JORDAN VALLEY WATER TREATMENT PLANT
FILTER AND CHEMICAL FEED UPGRADES

JVWCD PROJECT #4289

ADDENDUM NO. 5
TO THE
CONTRACT DOCUMENTS

June 2025

JORDAN VALLEY WATER TREATMENT PLANT
FILTER AND CHEMICAL FEED UPGRADES
STRUCTURAL
BACKWASH TANK
SECTIONS AND DETAILS 1

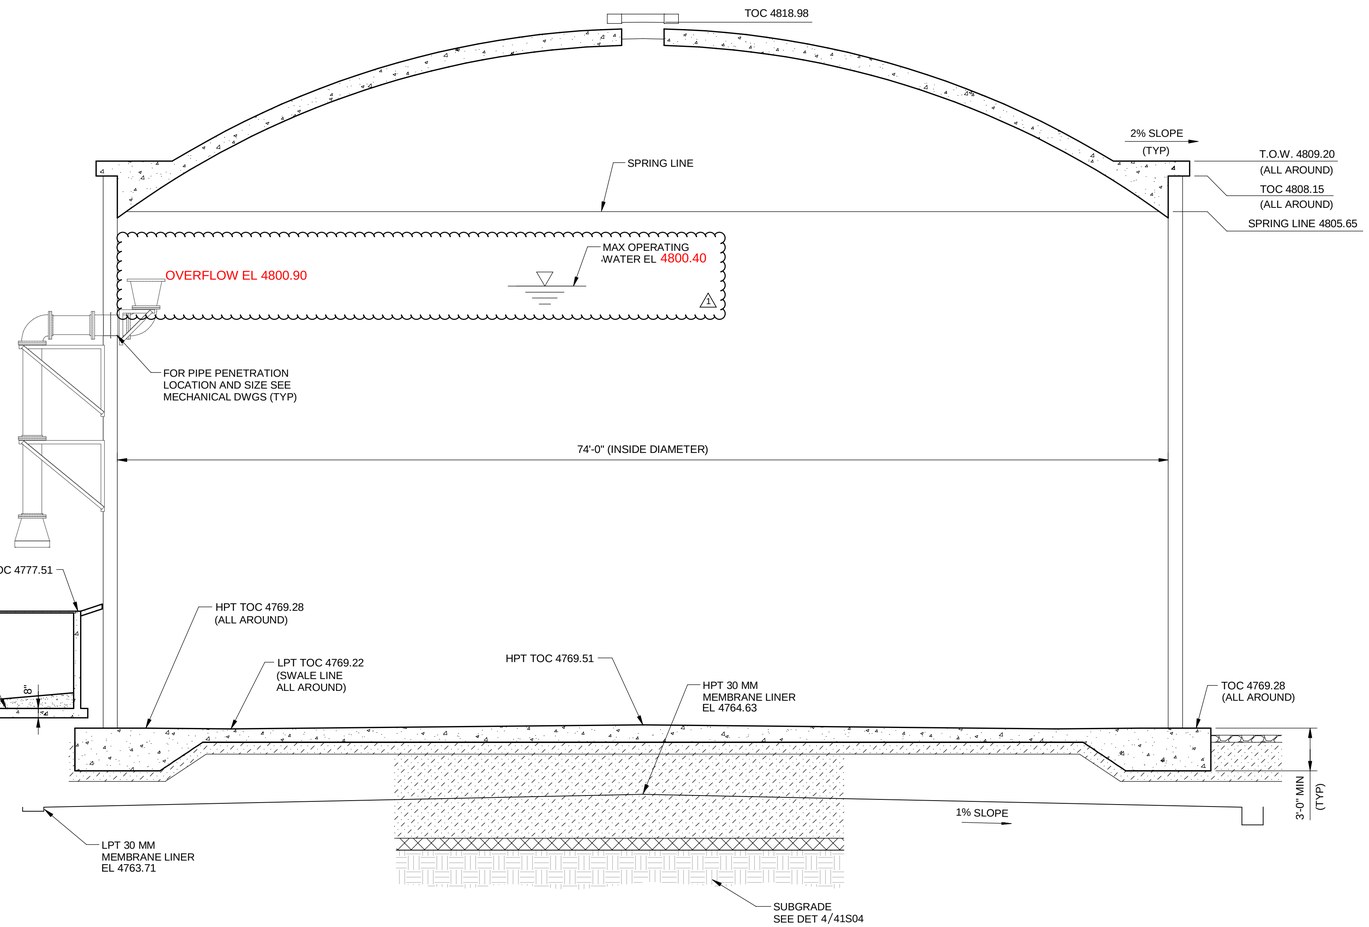
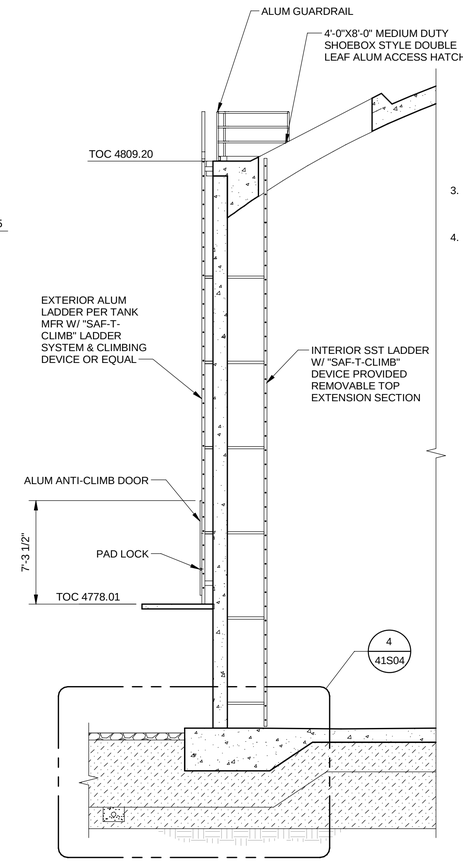
1. ALLOWABLE BEARING PRESSURE = [redacted]000 PSF. 1
3. INSPECTION OF REBAR BY ENGINEER REQUIRED PRIOR TO PLACEMENT OF CONCRETE FOR PIPE ENCASEMENT. VERIFY MINIMUM CONCRETE COVER AT TANK CONNECTION.

7	Geotechnical Report, Page 2, and Section 6.3.2.1 state a bearing capacity of 4,000 PSF. Plan Sheet 41S03, General Note 2.E. states a 3,000 PSF bearing capacity. Please confirm the allowable bearing capacity for the tank design.	The geotech sub has confirmed that a net allowable bearing capacity of 4,000 psf may be used for this area. 41S03 has been updated accordingly.
8	Page 12, section 4.5.2 in the geotechnical report notes the proposed tank location seismic site class as C. Table 2 on Page 13 notes the seismic site class as D. Drawing 00GS01, Structural Design Criteria - General, notes the seismic site class as C. Specification section 13207.1.06.D.10 notes the seismic site class as D. Please review and advise which site class is to be used for the seismic design of the tank structure.	Section 4.5.2 assigns site class C to this site. Table 2 on the following page only uses other classes as a default. All seismic design on this site should be for site class C and specification section 13207 has been adjusted to reflect this.

JORDAN VALLEY WATER TREATMENT PLANT
FILTER AND CHEMICAL FEED UPGRADES
MECHANICAL
FILTERS
SECTIONS AND DETAILS 6

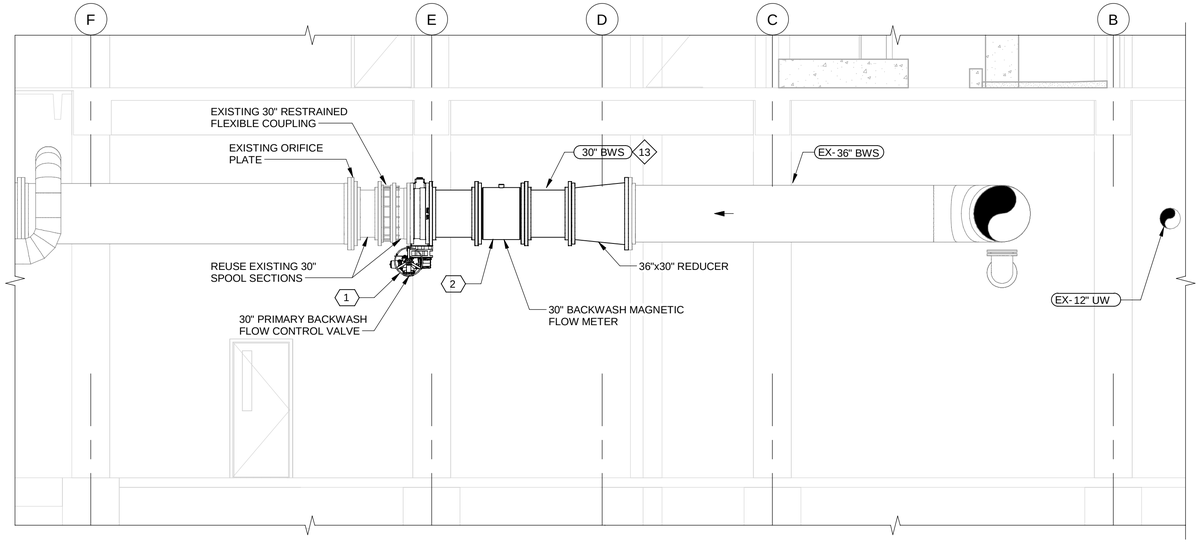
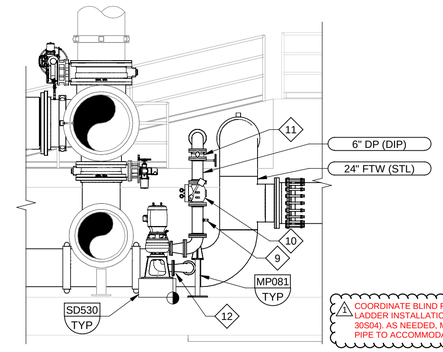
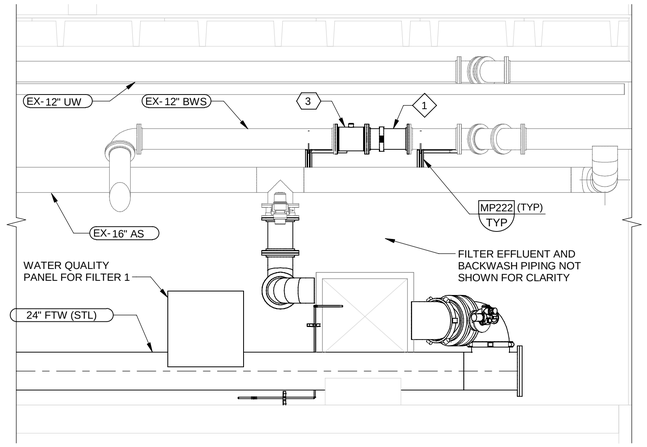
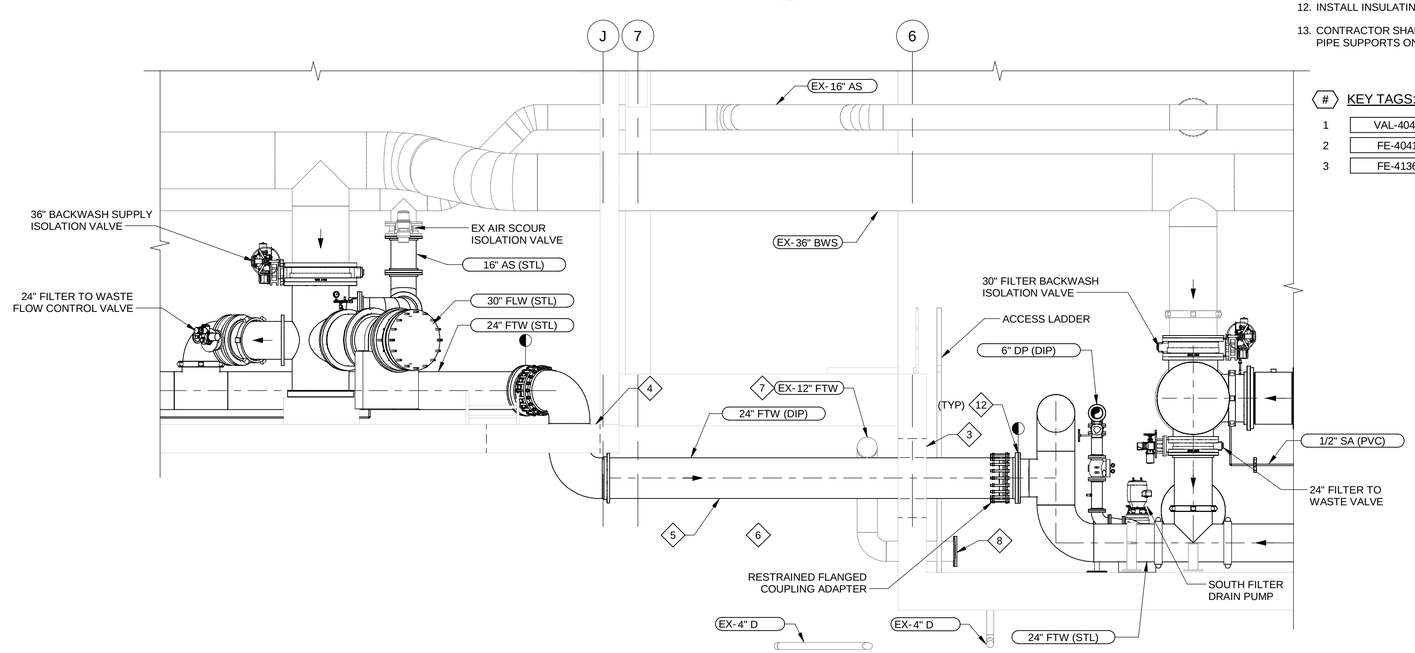
COORDINATE BLIND FLANGE INSTALLATION WITH LADDER INSTALLATION (SEE SECTION S ON DRAWING 30S04). AS NEEDED, MODIFY ABANDONED EX-12" FTW PIPE TO ACCOMMODATE THE NEW LADDER.

1. REPLACE EXISTING VENTURI METER WITH NEW MAGNETIC FLOW METER. INSTALL PIPE SPOOL BETWEEN METER AND EXISTING FLANGE WITH A RESTRAINED FLEXIBLE COUPLING.

7. PROTECT IN PLACE UNTIL NEW 24" FTW IS IN SERVICE. SEE WORK RESTRICTIONS. PIPE TO BE ABANDONED AFTER NEW FTW IS IN SERVICE.
8. REMOVE EXISTING GROOVED COUPLING ON 12" FTW. WELD ON FLANGE AND INSTALL BLIND FLANGE ON EXISTING 12" FTW. TYPICAL OF TWO LOCATIONS IN FILTER GALLERY.

JORDAN VALLEY WATER TREATMENT PLANT
FILTER AND CHEMICAL FEED UPGRADES
ELECTRICAL
ENLARGED SITE PLAN 1

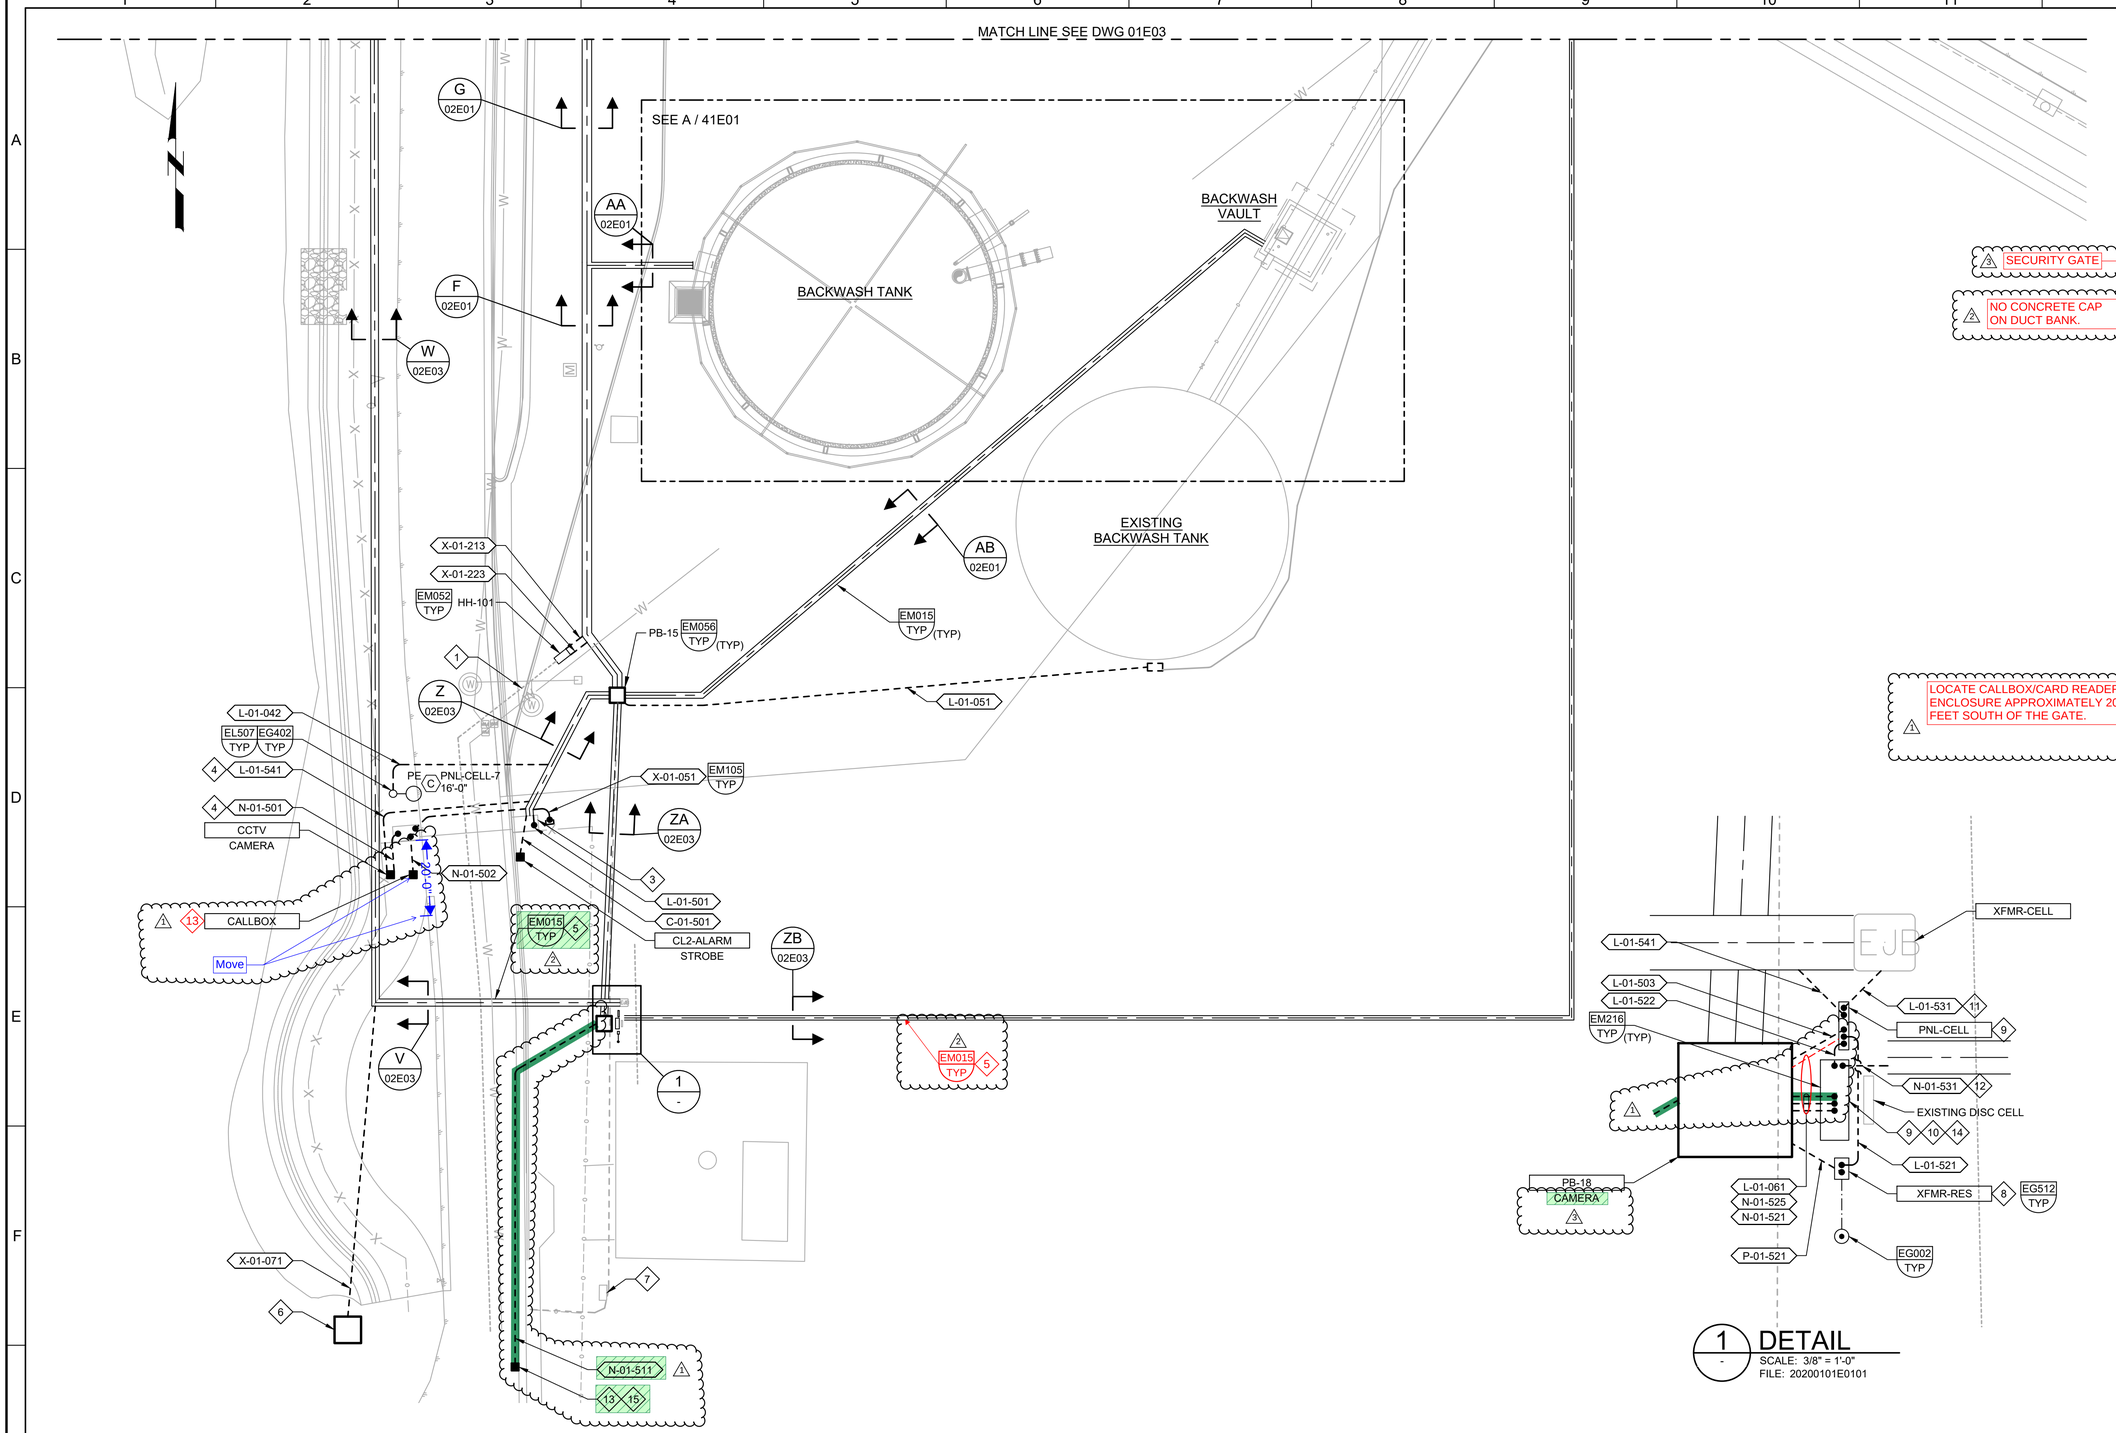
No.	Question	Response
1	In follow up to previous RFI answer and Addenda received regarding duct banks: Key Note #5 on 01E02 states "No concrete cap on duct bank." Does this apply to all duct banks or only to duct bank ZB? Please clarify.	Key Note 5 on drawing 01E02 applies only to duct bank ZB.
2	I want to confirm my understanding of Alternate A for the High-Performance Butterfly Valves. For the Base Bid, we are to include the cost of General-Purpose BFVs. If the High-Performance BFVs are less expensive, should Alternate A reflect a deduct? And if they are more expensive, should it show an adder? Alternatively, would you prefer that Alternate A reflect the total cost of the High-Performance BFVs, while the Base Bid still includes the General-Purpose valves?	Bid alternate A has been removed from the project, see addendum 5. All butterfly valves shall be high performance double offset.
3	Please confirm there are no domestic material requirements (i.e. Buy American, AIS, or BABA).	This has been confirmed by the owner. There are no union or buy American requirements.

JORDAN VALLEY WATER TREATMENT PLANT
FILTER AND CHEMICAL FEED UPGRADES
INSTRUMENTATION
P&ID
FILTER BACKWASH SUPPLY 1

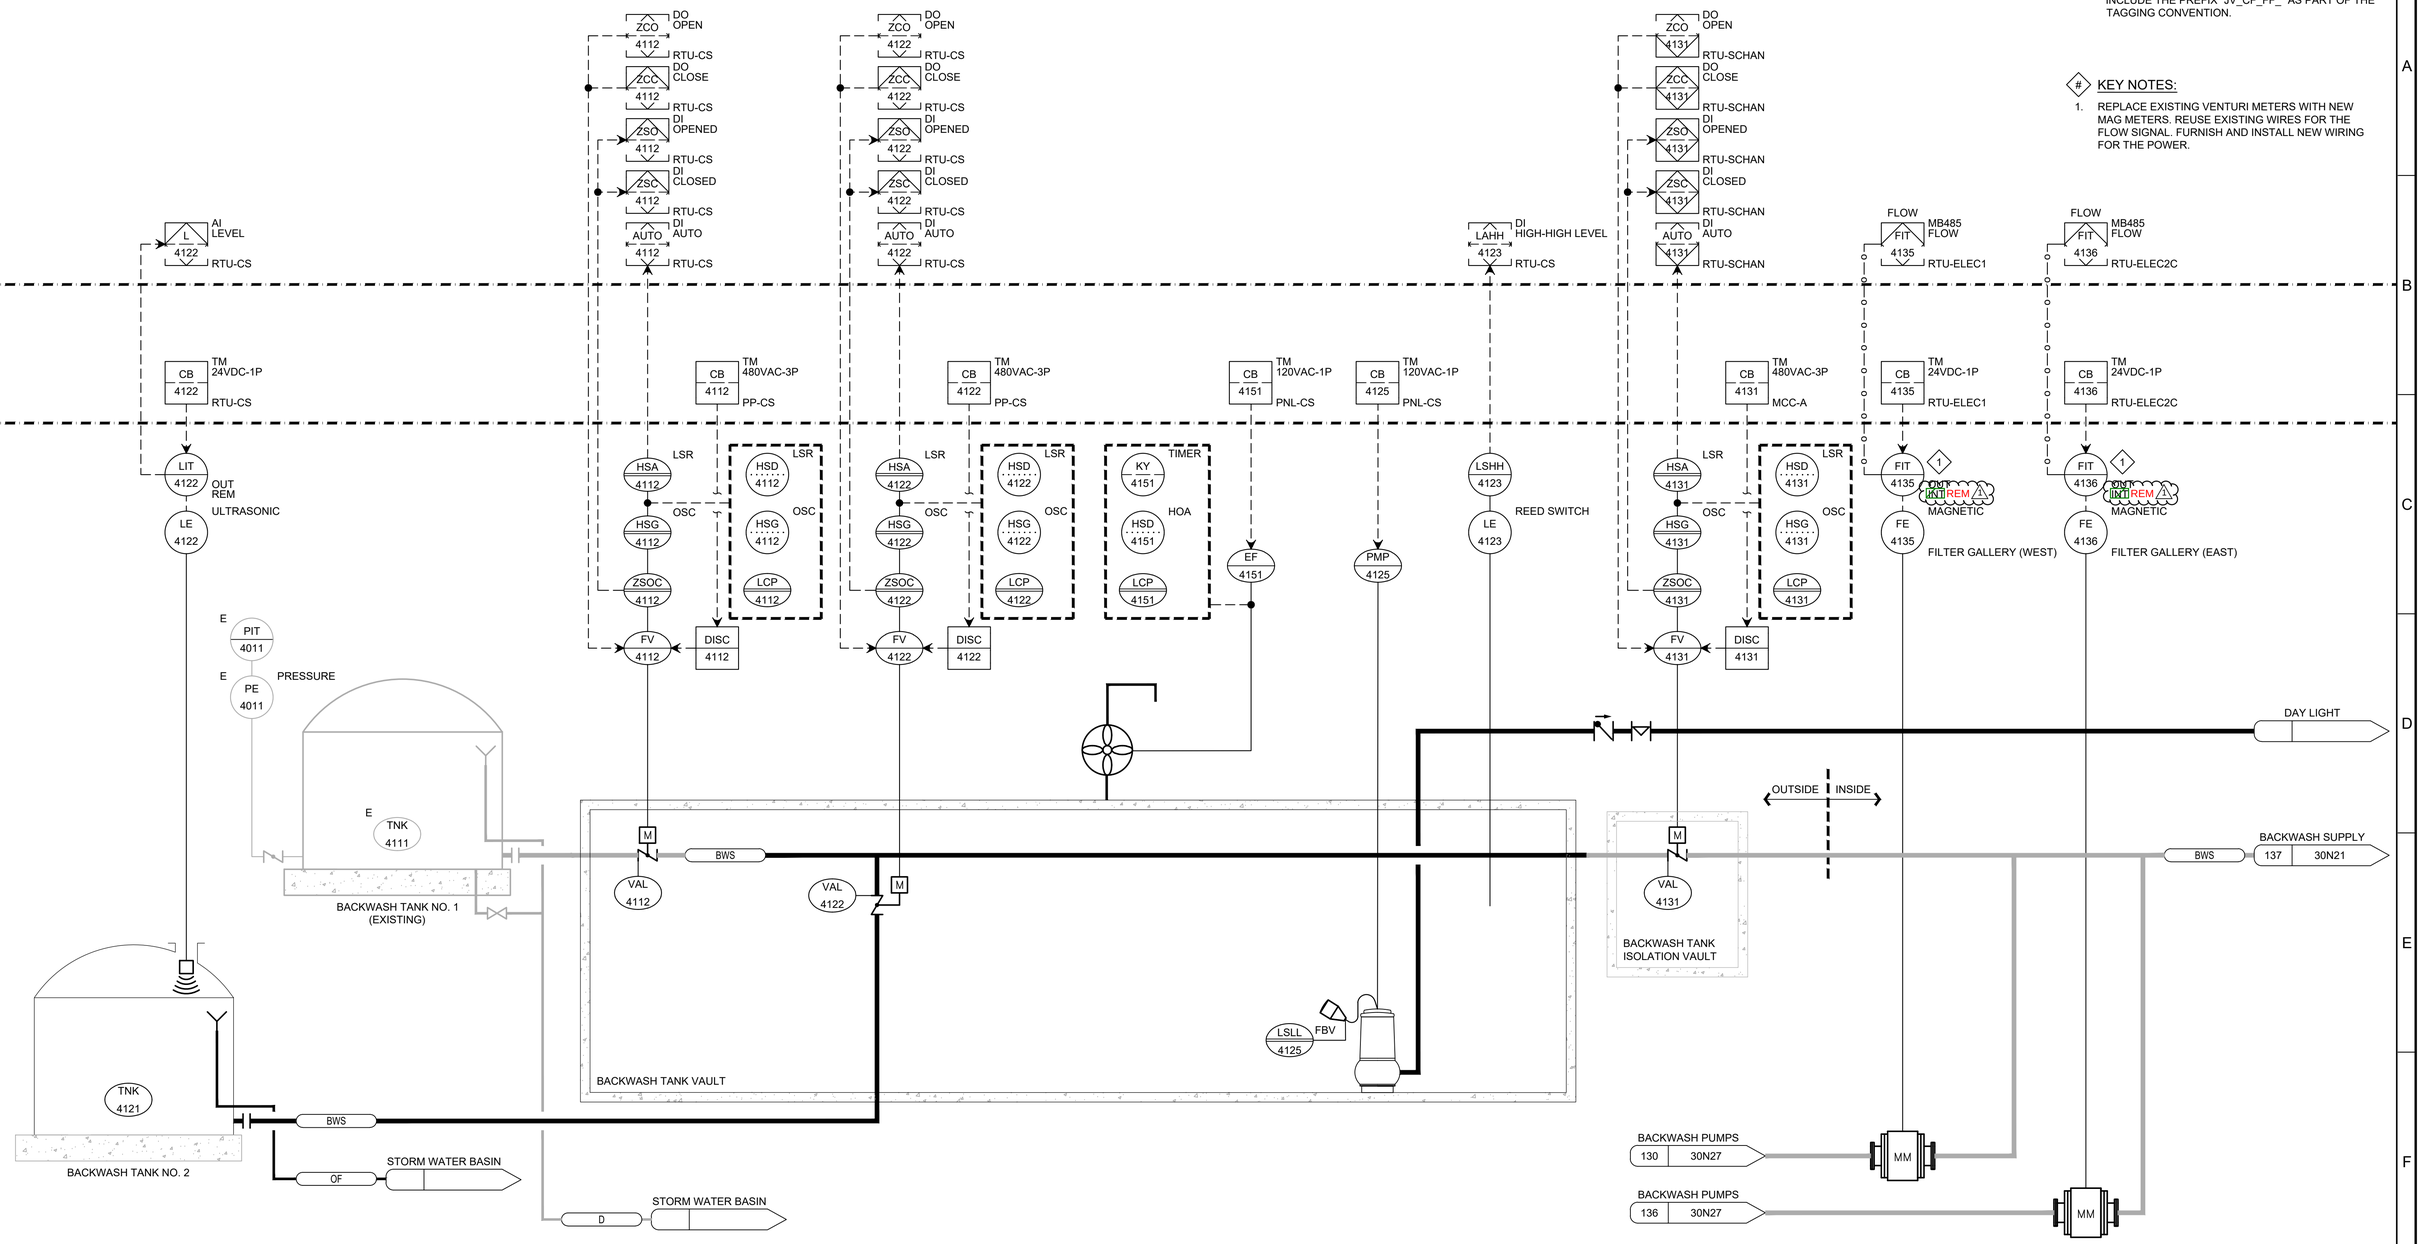
1. REPLACE EXISTING VENTURI METERS WITH NEW MAG METERS. REUSE EXISTING WIRES FOR THE FLOW SIGNAL. FURNISH AND INSTALL NEW WIRING FOR THE POWER.
